GEORGE MASON MEMORIAL, FOUNTAIN FOUR
West Potomac Park, East of Inlet Bridge over the Tidal Basin

Report to the National Park Service

November 4, 1999

ILLUSTRATIVE PLAN - TRELIS COURT

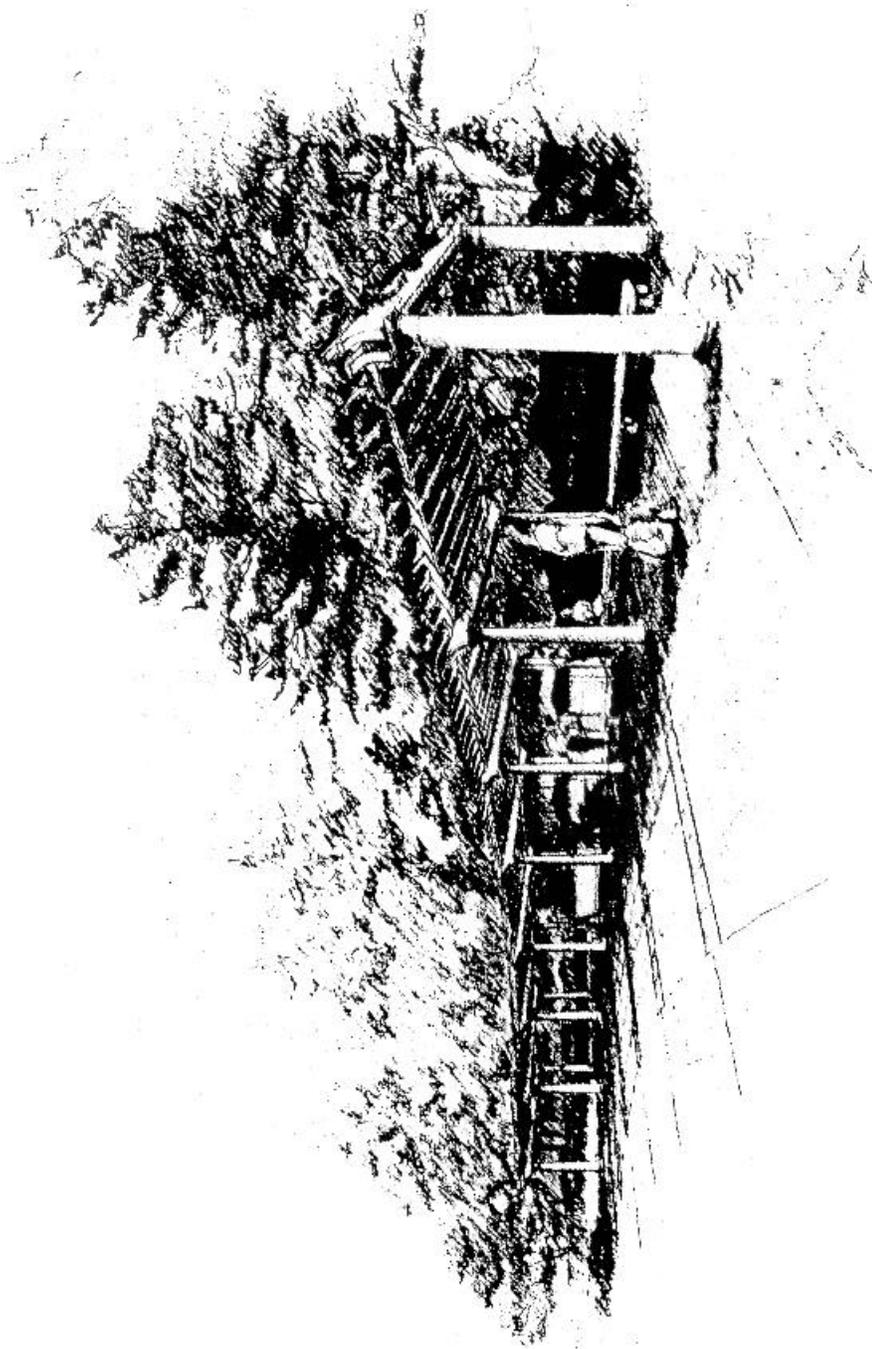
Although staff is supportive of the design concept, we feel that the relationship between the sculpture of George Mason and the trellis should be refined for the purpose of giving more significance to the sculpture, perhaps by aligning the sculpture on axis or opening up the trellis so that the sculpture will figure more prominently on the site.

- **Approves** the design concept for the George Mason Memorial, Fountain Four, West Potomac Park, East of the Inlet Bridge over the Tidal Basin, as shown on NCPC Map File No. 1.43(08.21)-40714.
- **Recommends** that the Board of Regents and the National Park Service, in the preparation of preliminary site and building plans refine the relationship between the George Mason sculptural element and the trellis with the objective of giving more prominence to the sculptural element.
